# UNITED STATES PATENT AND TRADEMARK OFFICE

APPLICATION NO.	FILING DATE	FIRST NAMED INVENTOR	ATTORNEY DOCKET NO.	CONFIRMATION NO.
09/941,934	08/30/2001	Joe Cargnelli	9351-072	6332

<b>Office Action Summary</b>	<b>Application No.</b> 09/941,934	<b>Applicant(s)</b> CARGNELLI ET AL.	
	<b>Examiner</b> Tho v Duong	<b>Art Unit</b> 3743

### **DETAILED ACTION**

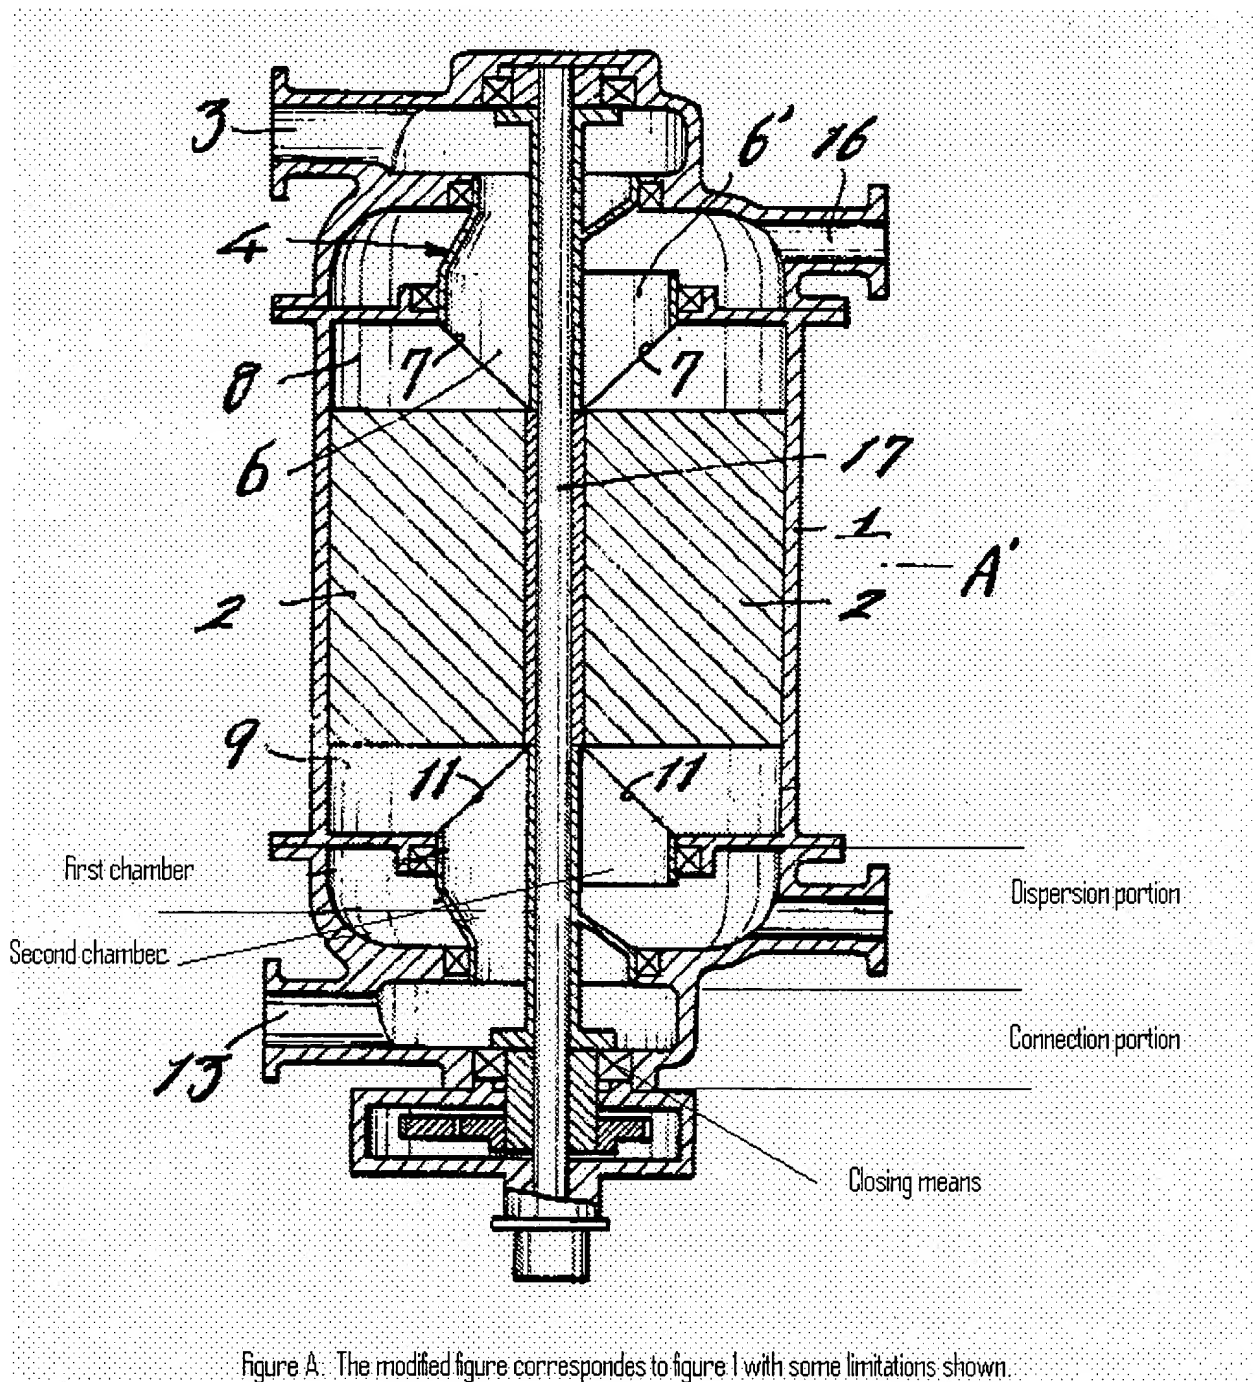
Claims 1-3,5,9,11-14,17-18,27,29-33,35-40 and 42 are rejected under 35 U.S.C. 102(b) as being anticipated by Nakajima Seiki (DE 2512065A). Nakajima discloses (figures 1-4 and A) a regenerative energy exchange assembly comprising an exchange media having a casing (101); a first chamber and a second chamber (6,6') having a first, a second fluid channels (12,15) adjacent the exchange media to pass a first fluid stream and a second fluid stream through the exchange media respectively; the first and second chambers separated by a divider; at least one fluid stream diverter (4) being rotatable orientation and providing separate flow communications (13,14) to the chambers through the respective fluid channels; the fluid stream diverter having a radial extent that is less than the functional radial extent of the exchange media, wherein, at any given diverter orientation, the separate flow communications (103,116) are not in fluid communication with the same chamber; a housing (manifold) connected to one end of the exchange media (1) and wherein the fluid channels are provided in the manifold; the manifold has interior walls defining an inner enclosure, and the fluid stream diverter is provided in the inner enclosure; the fluid stream diverter is rotatably mounted within the inner enclosure to provide the diverter within the adjustable orientation; a shaft (17,117) extends rotatably through the exchange media, and the housing (manifold), wherein the fluid stream diverter (4) is fixed to the shaft; the housing (manifold) comprises a connection portion and a dispersion portion which are in fluid communication with each other; the dispersion portion has an open end that is in fluid communication with the exchange media; the connection portion has one port (13) in flow communication with the respect fluid channel and has a radial extent that is less than the radial

extent of the dispersion portion; the dispersion portion comprises the first and the second chambers. Nakajima further discloses (figure 2) the exchange media is housed in a plurality of media cavities (2) that are separated from one another in cross section and extent in parallel along the exchange media; the plurality of media cavities are positioned in correspondence to the chambers of the dispersion portion; the plurality of cavities are disposed within the casing (1); the connection portion has an open end and a closing means (bearing) which closes the open end. Nakajima discloses (figure 1) the assembly has a first end housing and a second end housing disposed on either end of the exchange media; a first fluid stream diverter (4) is disposed within the end housing and a second fluid stream diverter (10) is disposed within the second end housing; the first and second fluid stream diverters are disposed correspondingly in the respective end housings and rotate by shaft (17) in phase during operation. Nakajima further discloses that the first fluid stream and the second fluid stream are in opposite direction.
